4620000 POST-TENSIONING  
COMMENTS FROM INTERNAL/INDUSTRY REVIEW

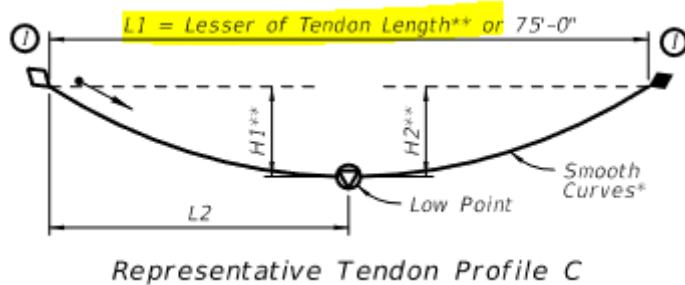
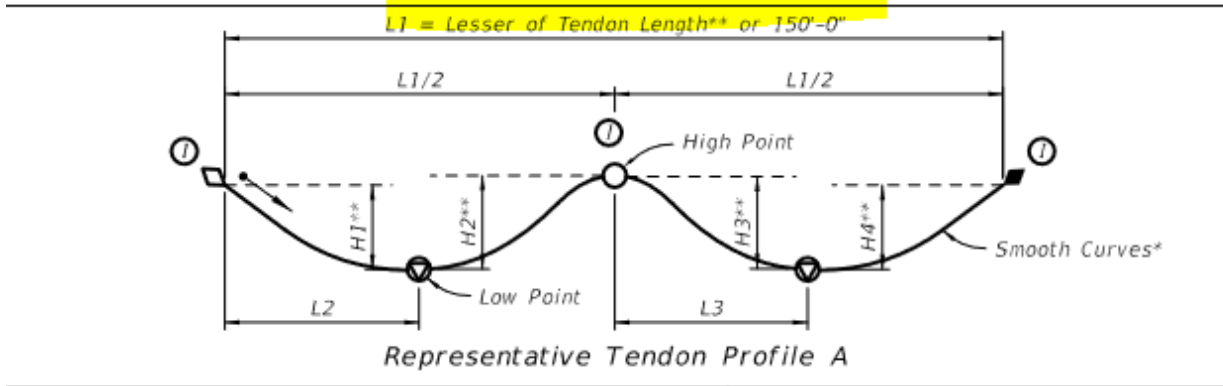
In Sub-Article 462-7.4.1.1 there is a requirement to perform full-scale mockups of a tendon using the same materials to be used in a permanent tendon. Has FDOT accomplished this successfully on previous projects? While this is not a change in this specification update, we have heard of issues on projects in other states when trying to perform this mockup. For really long continuity tendons (+400 feet) this becomes very difficult, because you have to put force into the tendon in order to get proper grouting results. It is very costly and hard to get good results due to the mock-up system being much more flexible than when the PT system is installed in concrete segments. Would it be possible to shorten the length of the mockup, or to perform more detailed testing and inspection of the first erected span?

- 1) Response: Please see section 1.11.5 of the Structures Design Guidelines. Projects referencing the 2016 version of the Structures Manual and later will use flexible filler for the continuity tendons.
- 2) Please note that per the Standard Plans Instructions for the 462 series, mockups do not require the use of corrugated plastic duct. Smooth PE duct is to be used for all mockups,

including mockups using grout.

- 3) The specific details of the mockup are handled on a per project basis. "Full Scale" does not always mean that the mockup must use the longest tendons. Please references the Standard Plans Instructions for the 462 series for further information. These requirements do not belong in the Specifications.
- 4) Please note that page 7 of the Standard Plans Instructions for the 462 series state that the mockup length is to be the lesser of the tendon length or 75 or 150ft depending on the tendon profile. Any further clarifications do not belong in the Specifications.
